Groundwater Application Review Summary Form

Application # G18844	
GW Reviewer Karl Wozniak	Date Review Completed: December 12, 2019
Summary of GW Availability and Injury Review:	
[] Groundwater for the proposed use is either of amounts requested without injury to prior water capacity of the groundwater resource per Section	
Summary of Potential for Substantial Interferen	nce Review:
[] There is the potential for substantial interfere	ence per Section C of the attached review form.
Summary of Well Construction Assessment:	
[] The well does not appear to meet current we review form. Route through Well Construction as when well with the construction as the construction of the construction	ell construction standards per Section D of the attached and Compliance Section.

Review of Water Right Application G-18844

Water-Level Trends in Nearby Wells

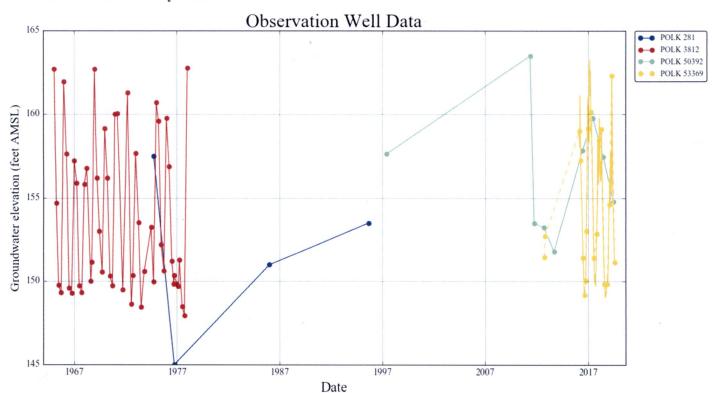
B3. **Groundwater availability remarks:** The applicant proposes to use 0.1 cfs (45 gpm) for primary irrigation of 8 acres from 1 well, POLK 54325, which produces from unconsolidated sands and gravels in the Holocene floodplain of the Willamette River. The well is located inside a meander loop of the river which is bounded by low-permeability bedrock at the edges of the floodplain. The average saturated thickness of the aquifer in the floodplain is about 30 feet but the water table fluctuates 10-15 feet during the year largely in response to changes in the stage of the Willamette River (see plot below). Water levels in a nearby recorder well (POLK 53369) indicate that seasonal low groundwater levels occur in late August and early September, coincident with the lowest flows in the Willamette River.

Well Statistics Sections 2, 3, 10, 11, 9S/4W: Domestic Wells (6-inch casing)

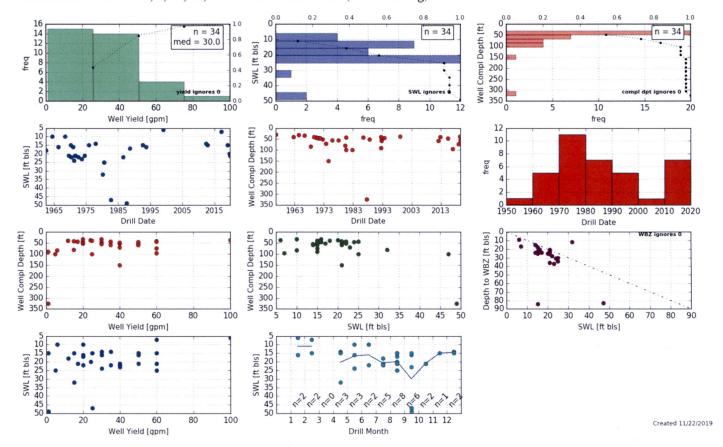
The well log for the subject well notes that it a domestic well with 6-inch diameter casing and a reported air test yield of 50 gpm. Similarly constructed wells in the nearby area show a median yield of 30 gpm but yields of 50 gpm are common. Well logs for nearby irrigation and community wells commonly show yields of 500-1000 gpm. Therefore, it seems likely that the well will be able to produce 40-50 gpm.

Well Location Map

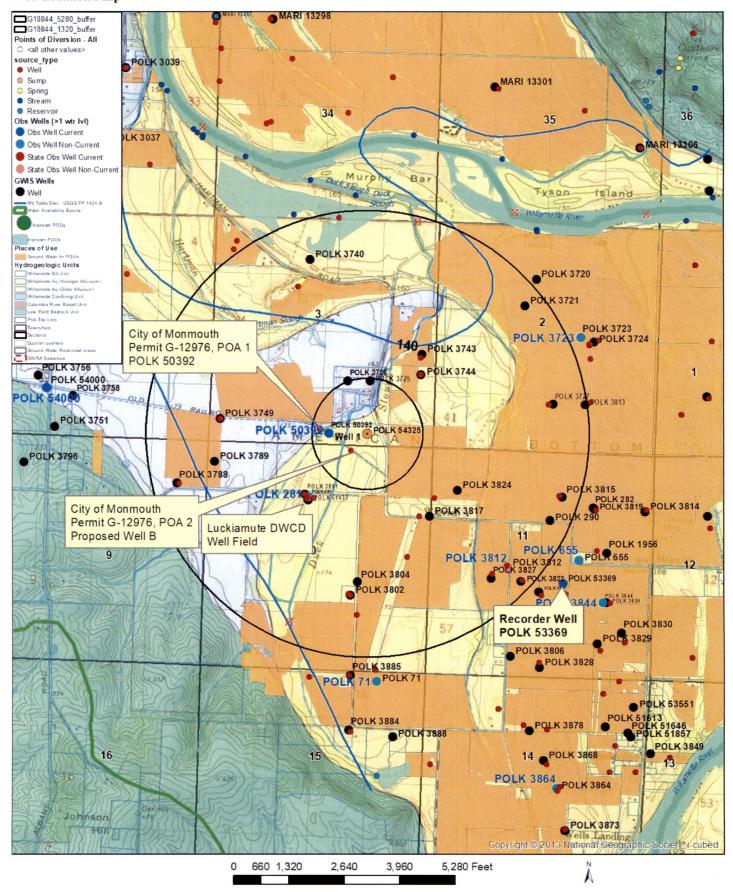
Irrigation well density is relatively high in the surrounding area but the nearest permitted wells are all greater than 1900 feet from the subject well. The Luckiamute Domestic Water Cooperative operates an active well field about 2000 feet to the southwest which contains four high-capacity community wells (POLK 281, 3801, 3802, & 51437); the OWRD water-use reporting database indicates the well field pumped an average of 566 acre feet per year for the water years 2016-2018. The City of Monmouth has a permit (G-12976) that allows the maximum use of 6.0 cfs from 2 community wells in the area just west of the subject well. Only one of these wells, POLK 50392, has been drilled to date at a distance of about 1000 feet to the west. Extensive testing of the well in 2001-2003 indicated substantial interference with the Luckiamute wells to the south and the presence of excessive concentrations of iron and manganese. For these reasons (per information in the associated water right file, G-13521), the city has never put the well into service, no longer plans to place it in service, will not drill the second well (proposed location about 550 feet west of the subject well), and plans to transfer the production right to wells in other locations.

A number of rural residential tax lots are located within 250 feet to 1/4 mile of the subject well but the precise location of domestic wells on these lands is unknown. Analytical modeling (see Theis interference plot below) with conservative hydraulic parameters (K = 250 ft/day, S = 0.1, and b = 25 feet) shows a maximum hydraulic interference of about 0.7 feet at a distance of 250 feet after 245 days of continuous pumping at 45 gpm. These results indicate that POLK 543\$5 is unlikely to cause substantial interference with the nearest domestic wells or with nearby irrigation and community welfs. On the other hand, the large combined pumping rates of the community wells and nearby irrigation wells may result in severe interference with the subject well, especially in the late summer months when groundwater levels are low because of low water levels in the Willamette River. Analytical modeling of interference to the subject well from a well pumping 1000 gpm at a distance of 2000 feet (see plot below) indicates about 5 feet of hydraulic interference after 245 days of continuous pumping, again with conservative hydraulic parameters. Actual values for hydraulic conductivity (K) and storativity (S) are expected to be higher which will reduce the predicted impacts. Nevertheless, the impacts of all nearby wells will be additive which indicates the potential to significantly diminish the available water column in the subject well during the late summer months.
